PLANNING CLEARANCE

Building Address 2666 Liberty View Ct
 Parcel No. 2945-264-41-007
 Subdivision Spy Glass Ridge
 Filing 1 Block _____ Lot 70

RE: 2666 Liberty View Ct. (Lot #70)
Spyglass Ridge Development

SITE DRAINAGE PLAN 1" = 10'

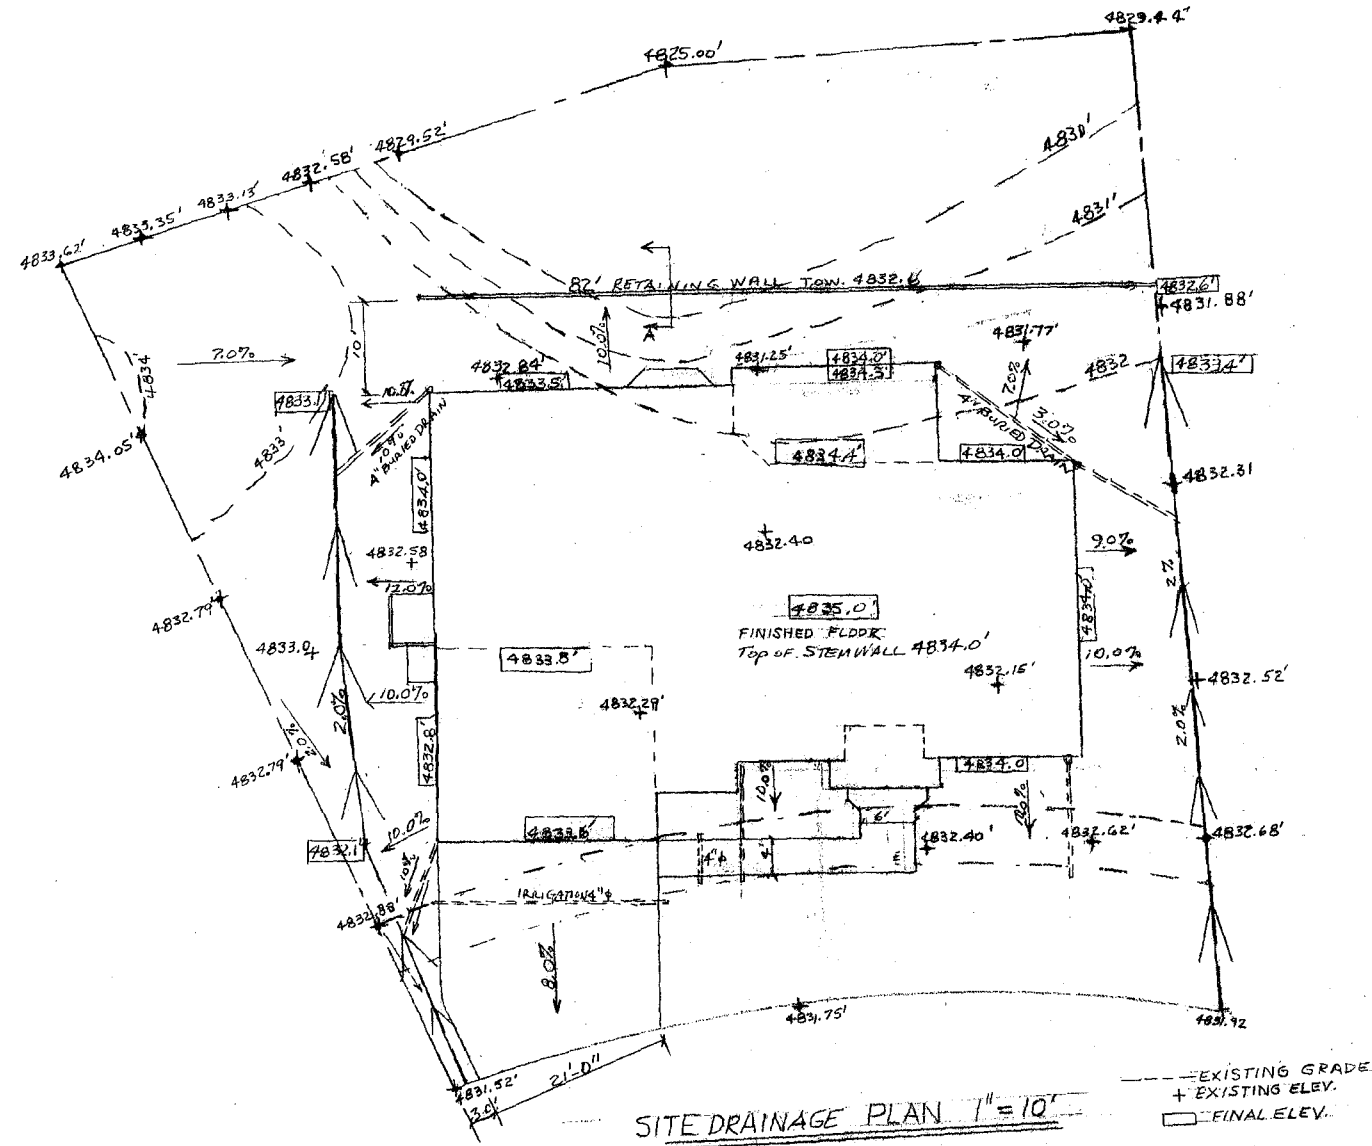
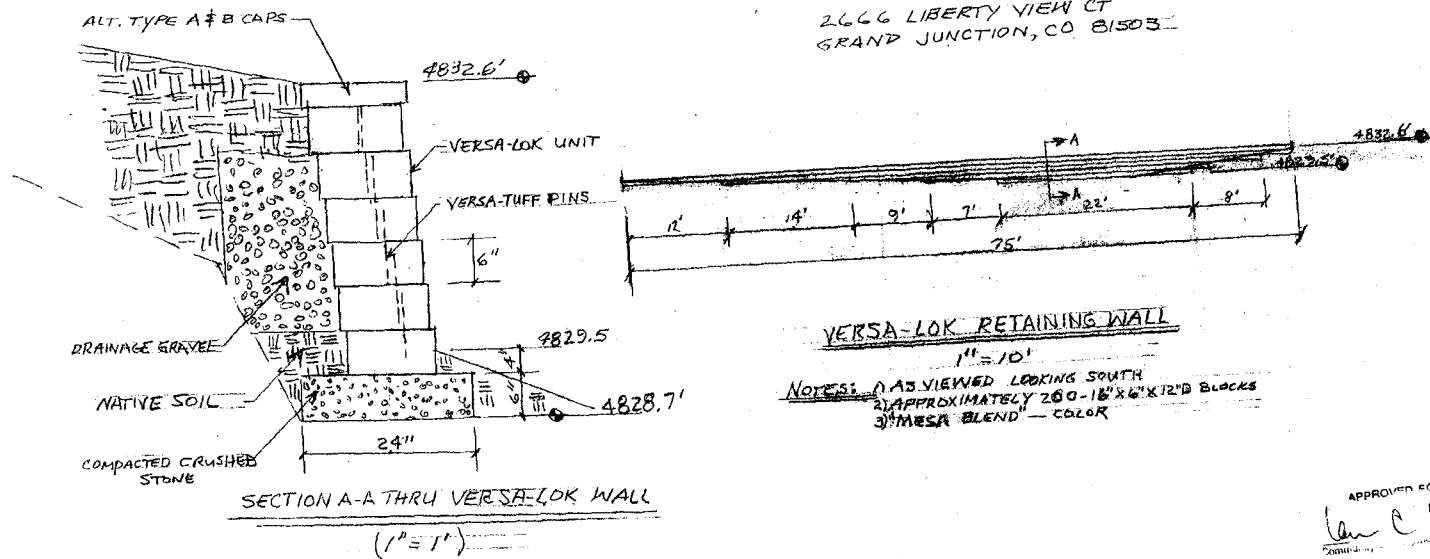
Please accept my apology for failing to realize that the runoff from the developed area of this lot must drain to the street. Somehow this requirement was missed in my review of the project development documents. The plan has now been revised accordingly and two copies attached hereto for your approval. Specifically:

- The finished floor has been raised 6" to 4835' with the top of stem wall now set at 4834.0'.
- The retaining wall across the rear has been lengthened to 82' and the top of wall raised 6" to 4832.6'. Because the original surface area draining toward the north extended into approximately the center of the house, there will now be less surface runoff to the north than previous historical amounts.

- Grades have been set to provide a 10% slope for a minimum of 10' around the structure.
- All eaves are fully guttered with all downspouts now discharging into 4" diameter underground drainage systems, all of which discharge into drainage ditches which slope a minimum of 2% toward the street.

- The final landscaping plan, once completed, will stipulate that no grass is allowed except as may be approved between the house and the street, and any bermed areas that may be created can not alter the current drainage as designed.
